RE: H59-6060-MJ: Horry Georgetown Grand Strand Culinary Building Construction

ADDENDUM #2

P402

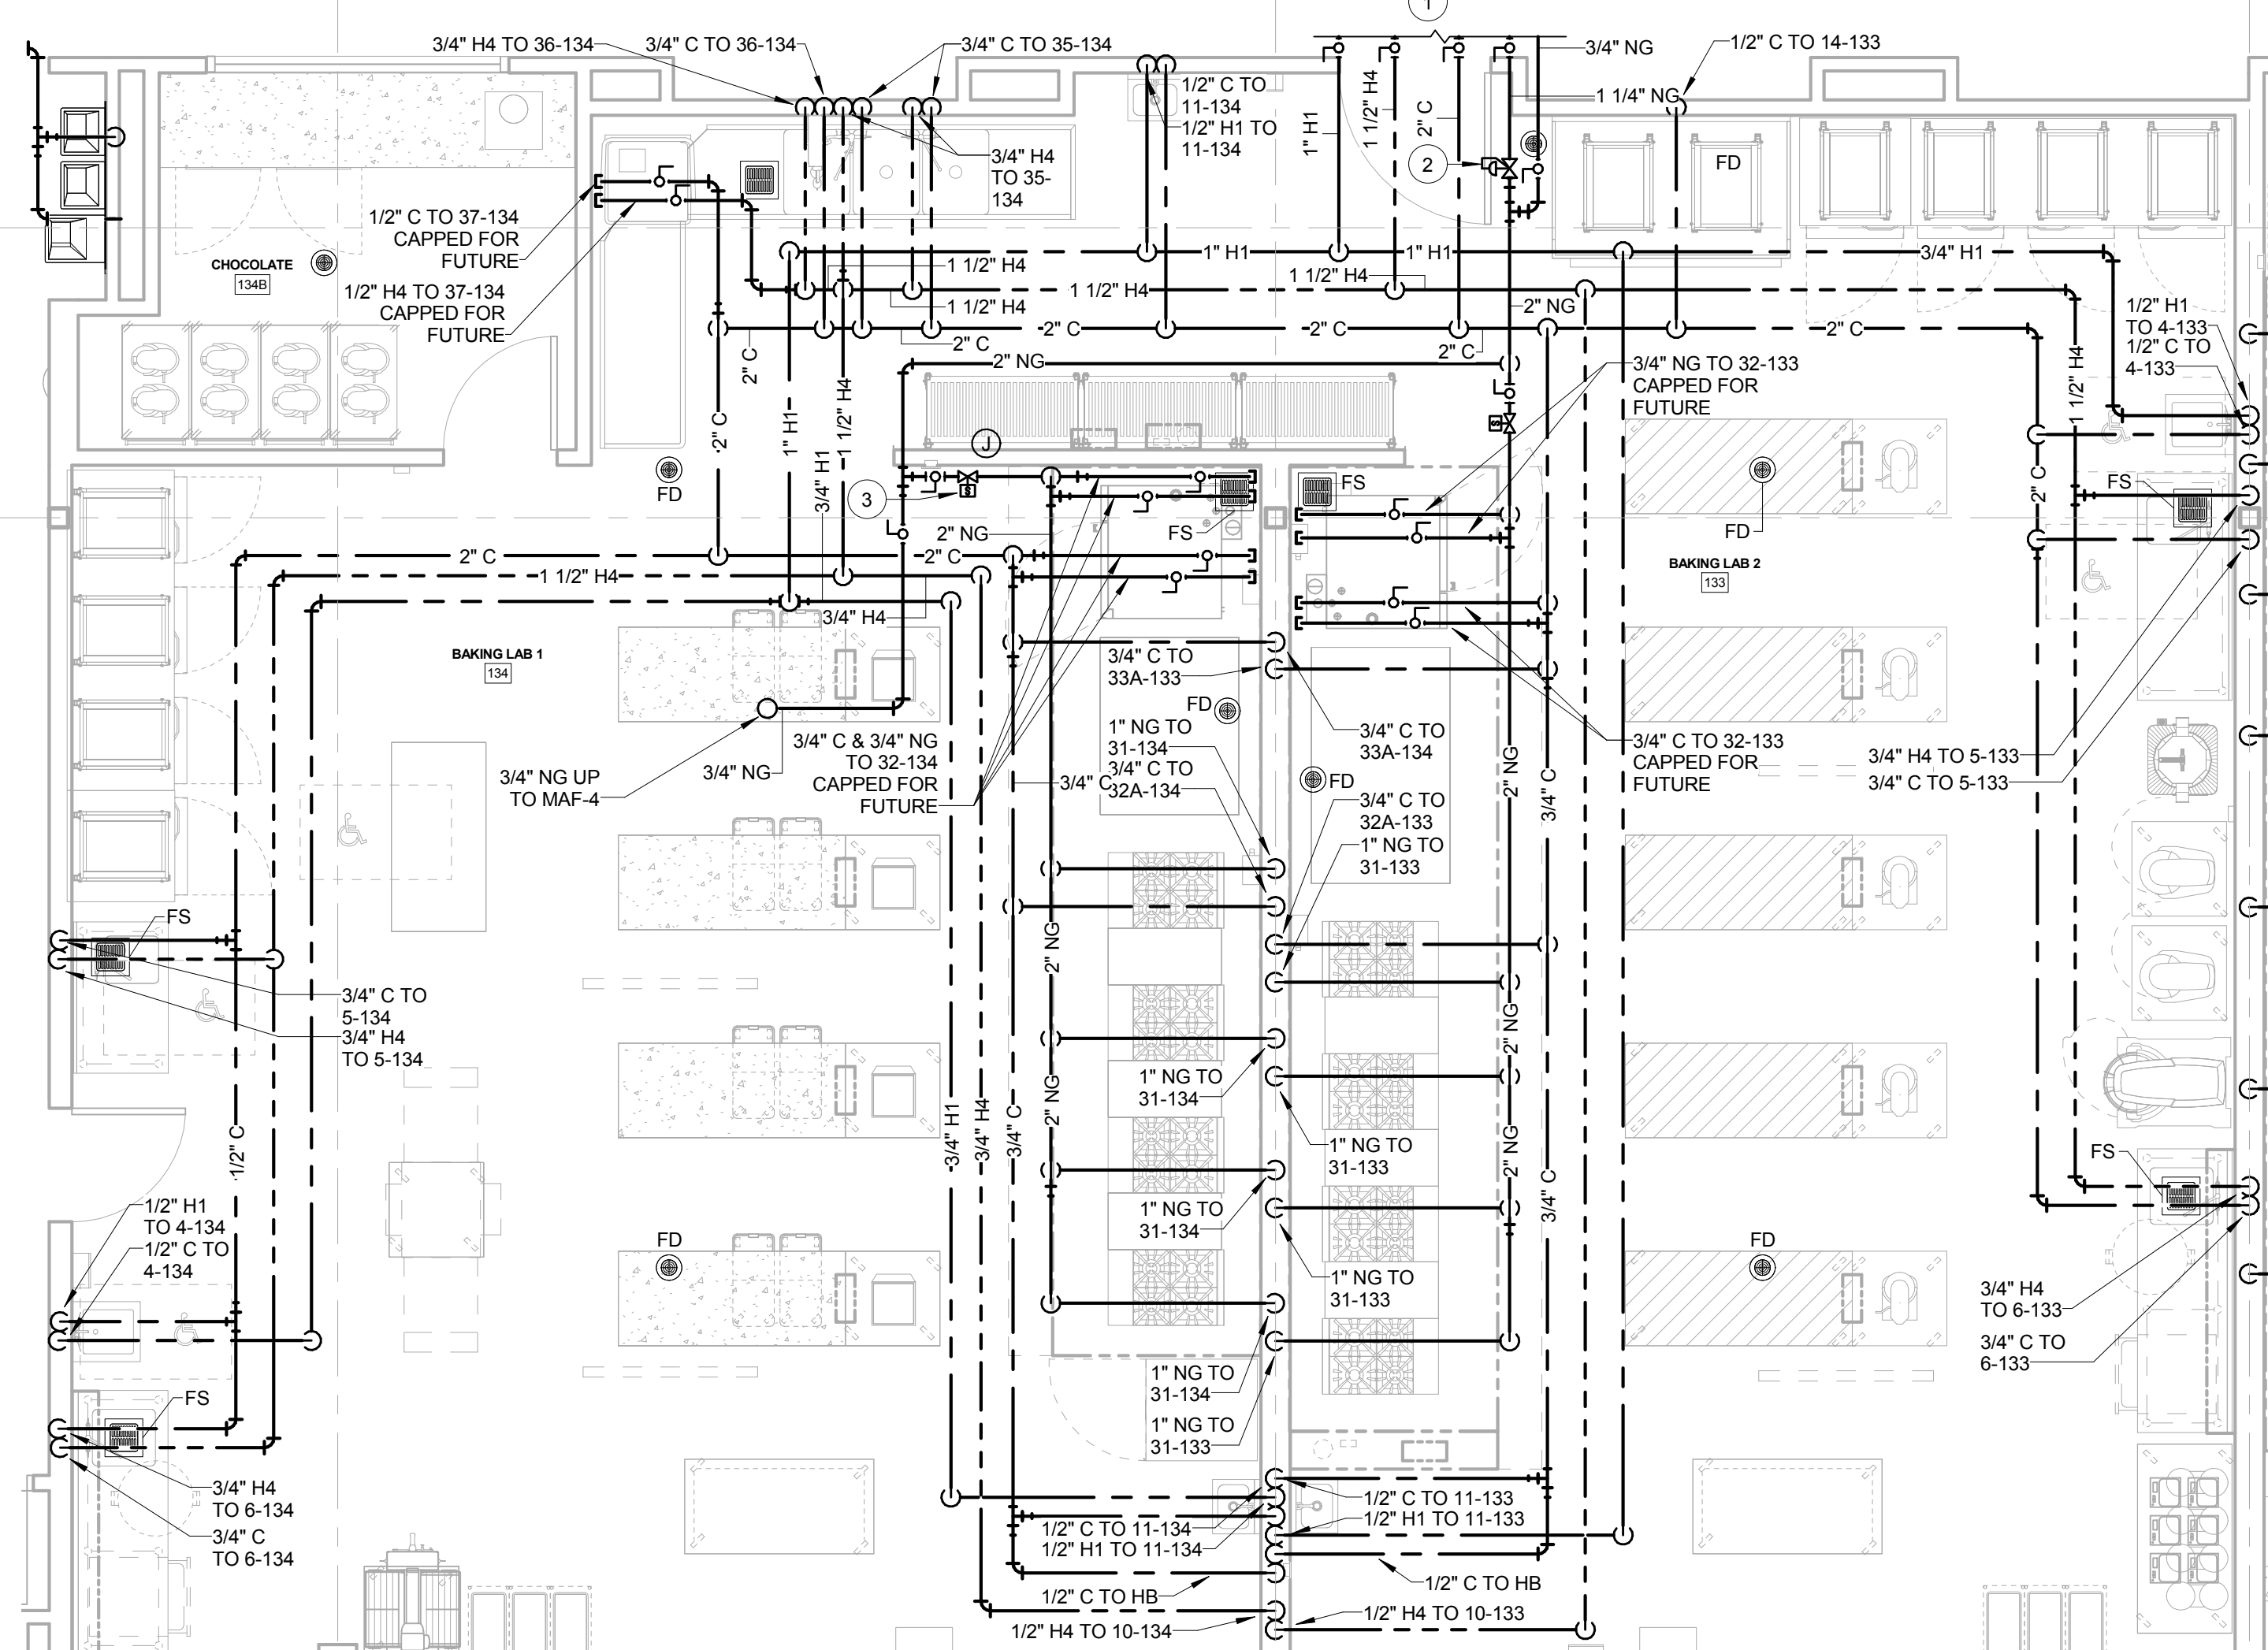
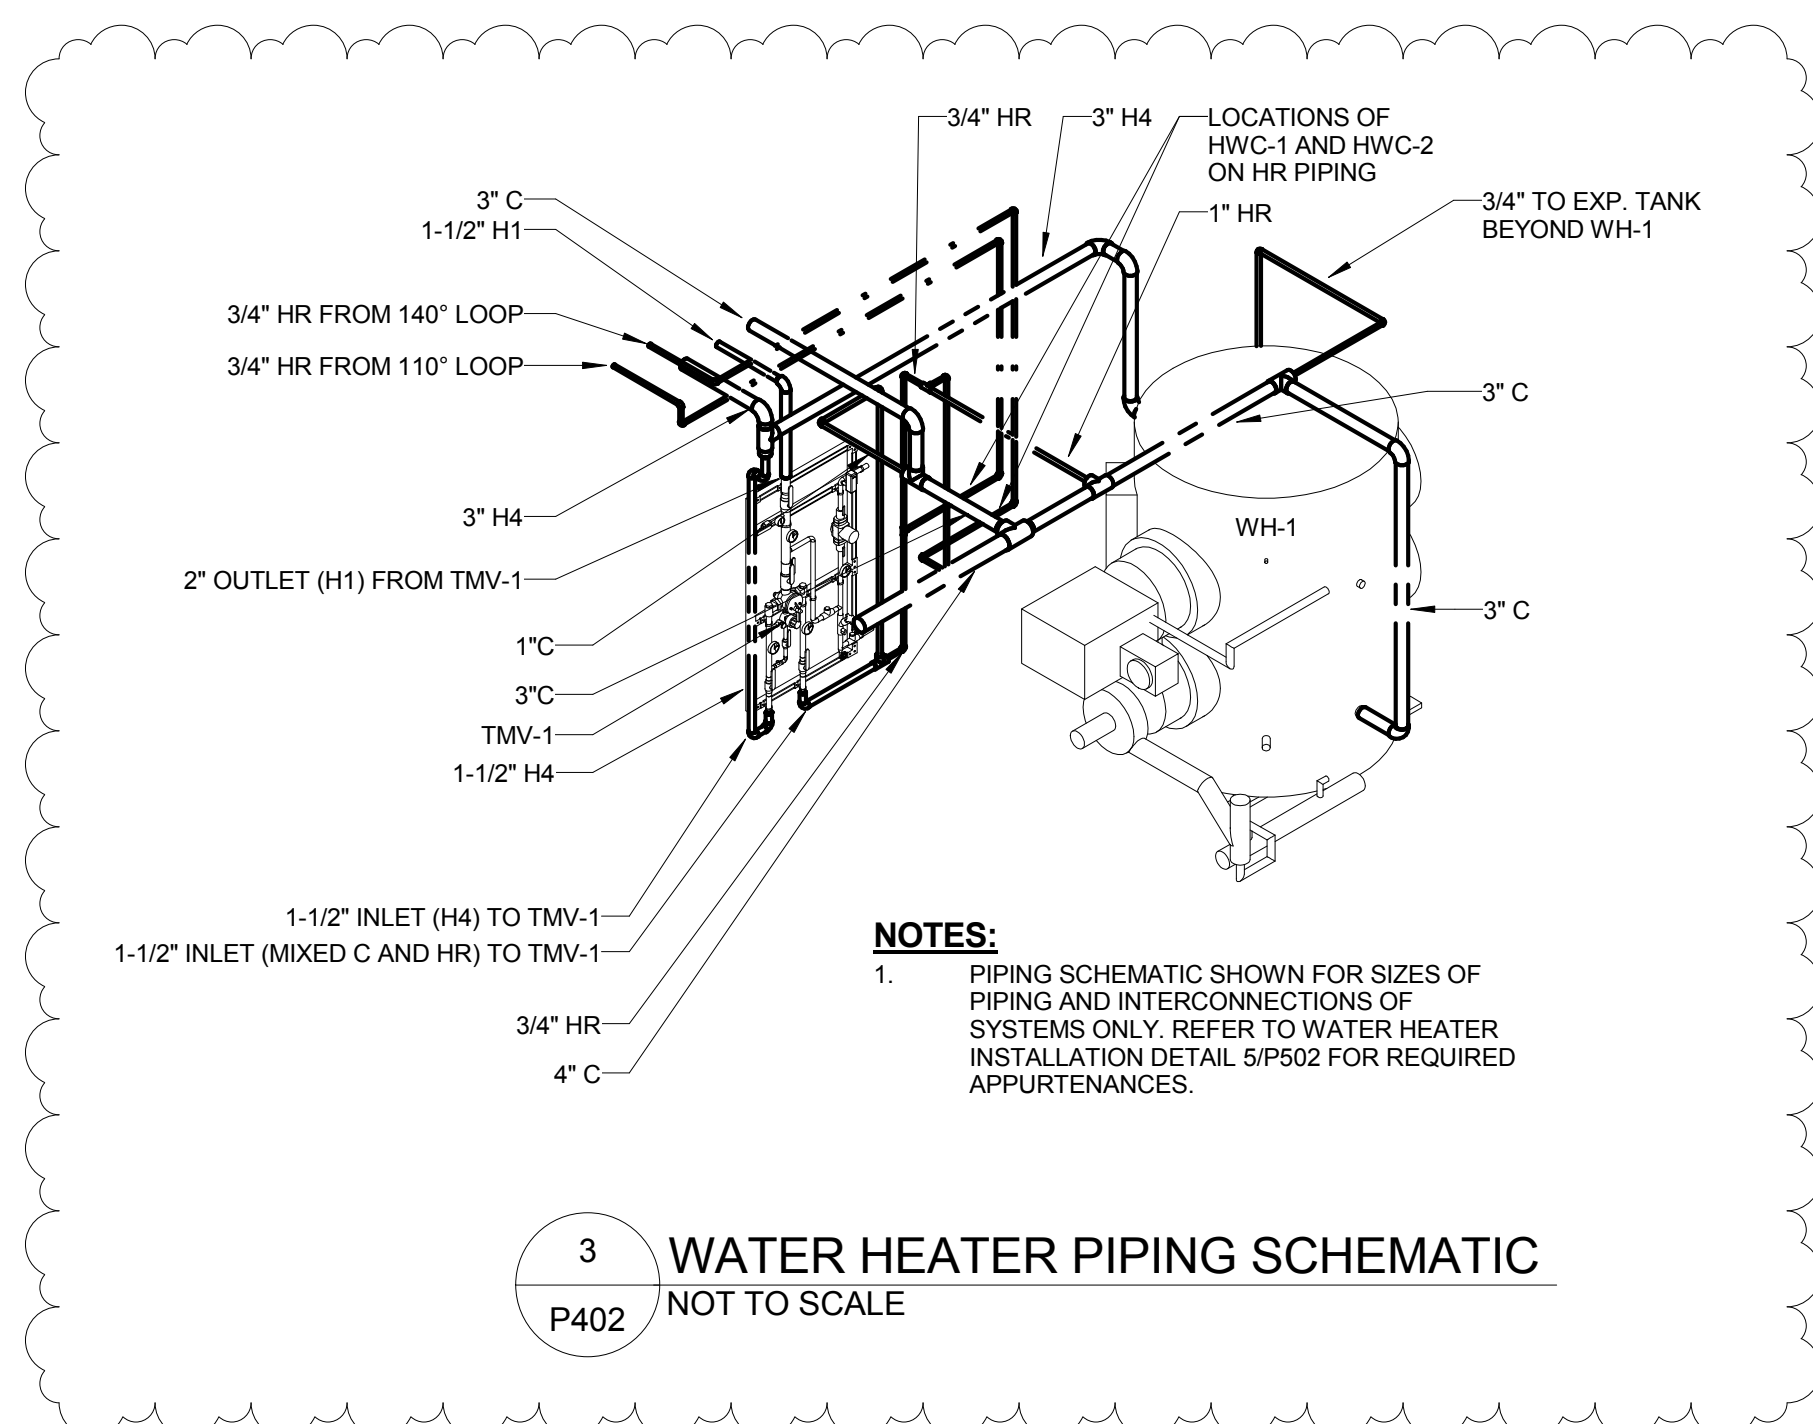
Sheet P402 – Plumbing Domestic Water & Gas Enlarged Views **Reissued**. Detail 3/P-402 has been added. Revised sheet in Adobe.pdf format attached to this Addendum.
